# Determination 2024/067

**Regarding compliance and decisions in relation to building work to construct four new dwellings with Clause E1.3.1 as it relates to the protection of other property at 32 and 32A Wolsley Avenue, Milford**

This determination concerns building work associated with the construction of four new dwellings. The determination considers the compliance with Clause E1.3.1 of the Building Code in relation to protection of other property from surface water.

Figure 1: Site plan showing 30, 30A and 32 Wolsley (not to scale)

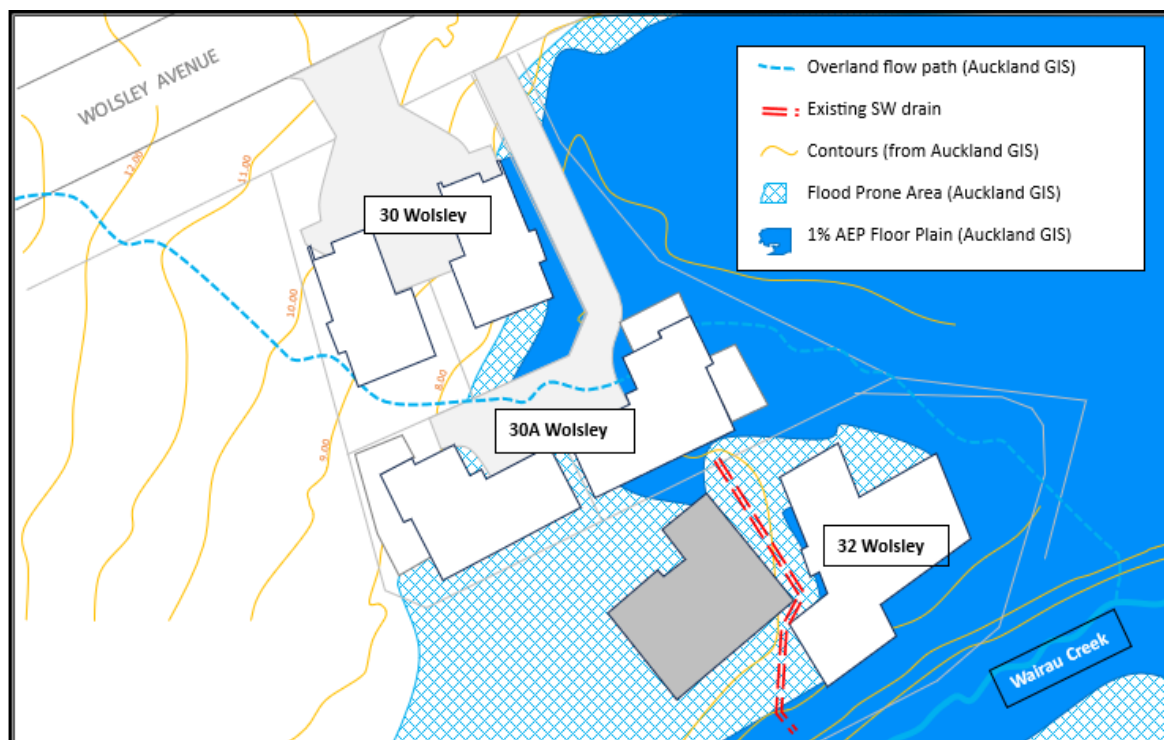
- 4.3.1. The development of 30 Wolsley will obstruct the overland flow path. "A proper hydraulic analysis of the flow should have been carried out, rather than defining the flow as sheet flow with no basis."

- 4.3.2. The retaining wall at 30A Wolsley along the boundary with 32 and 32A Wolsley obstructs the overland flow path. The flow will not be a sheet flow of no depth as claimed and the drainage for the retaining wall does not have capacity to accommodate significant surface water flow.

- 6.19. Changing the course of the surface water will have an impact on water entering 32 Wolsley. I do not agree with the assumption that the changes can be dismissed as a 'sheet flow of little depth and across a wide extent'. The concentration by the dwellings and associated impervious area and their locations results in the surface water flow entering 32 Wolsley in different locations from pre-development, at an increased velocity due to the concentration of flows on the east of 30 and 30A Wolsley, and through the centre of 30A. In addition, the retaining walls on the eastern boundary of 30 and 30A Wolsley direct water flows toward the southeast boundary and between the two dwellings on 30A Wolsley. These add up to a situation where the natural contours and flow paths leading downslope to and across 32 Wolsley no longer carry the surface water to Wairau Creek the way they did previously.

**Figure 2: Stormwater connection at boundary of 30A and 32 Wolsley Avenue**

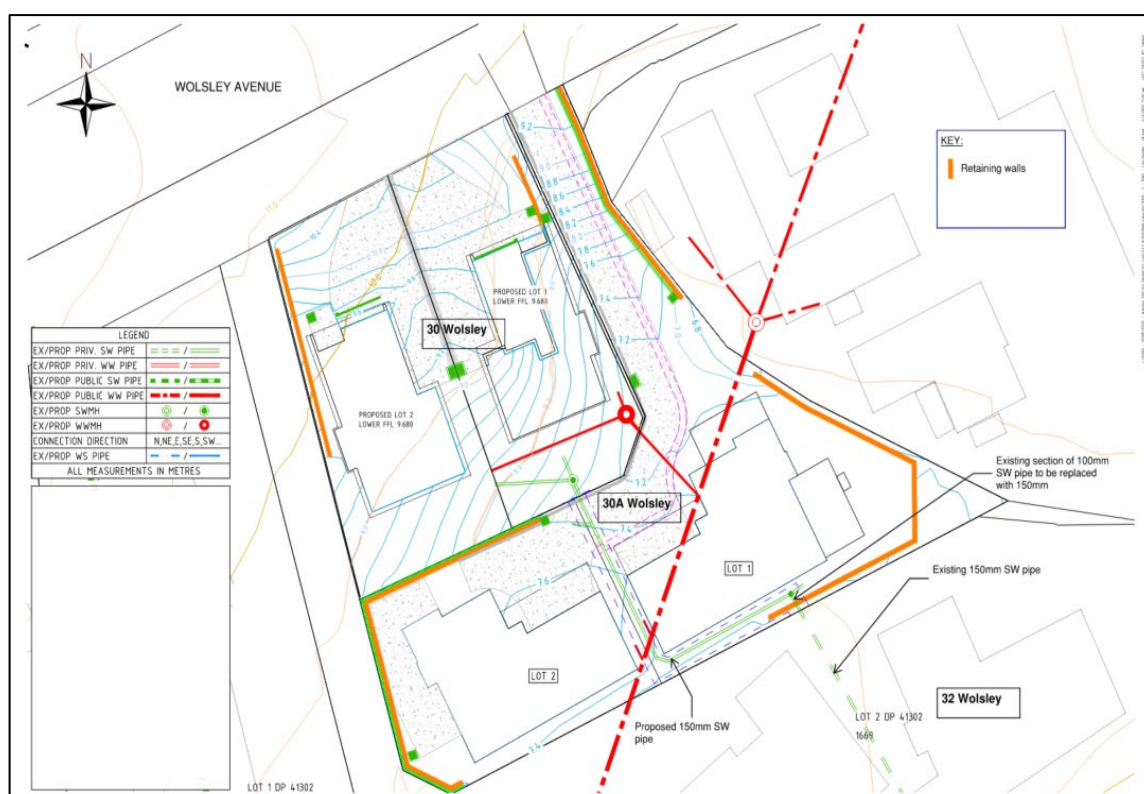
- 6.17. The proposed design intended the surface water to drain from the attenuation tanks to the pipe outlet at the boundary of 32 Wolsley. I am of the view that a pipe size of 150mm will not be sufficient to take the flow in a 10 %AEP event. This drainage system will then backup, which will lead to greater uncontrolled surface water discharges that will flow down the slope into 32 Wolsley, leading to a further increase in surface water flowing across 32 Wolsley. It will also impede the roof drainage on 32 Wolsley.
